CERTIFICATE OF APPROPRIATENESS

Property: 801 Key Street, Lot 18, Block 221, East Norhill Subdivision. The property includes a historic 1,414 square foot, one-story wood frame single-family residence and detached garage situated on a 6,157 square foot (59.20' x 140.00') corner lot.

Proposal: Alteration – Construct an approximately 1,100 square foot two-story addition on top of, to the side of, and to the rear of a contributing structure.

Recommendation: Denial - does not satisfy criteria 1, 4, 8, 9

DEMOLITION PLAN 1

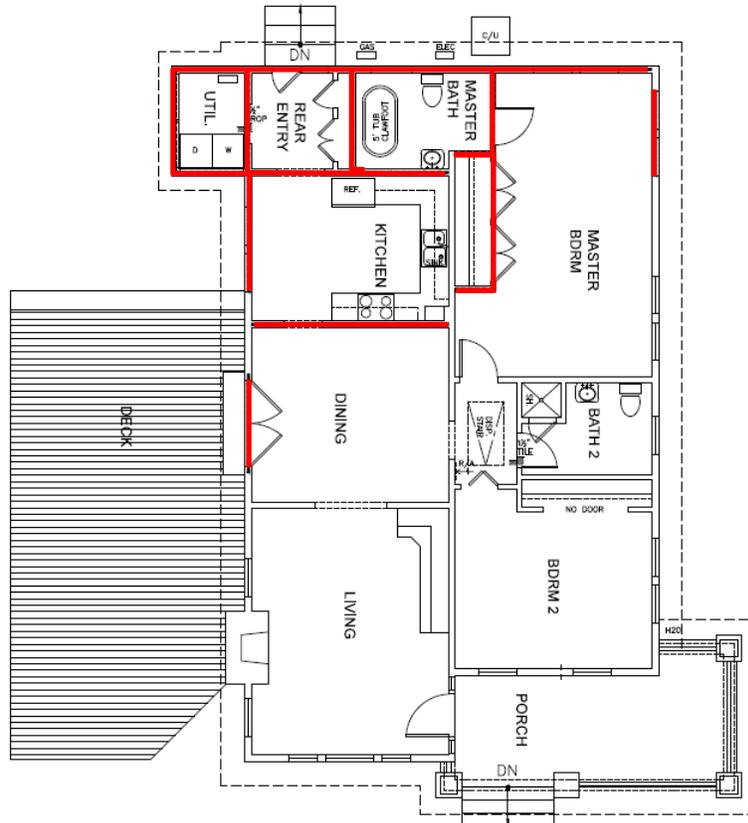
<i>Constructing a second-story addition atop half of an existing one-story building while removing and altering large sections of the rear third impairs the form and integrity of the existing historic structure.</i> |

<i>The one-story portion of the addition and alterations towards the rear of the structure removes a significant portion historic of material, including siding and windows.</i> |
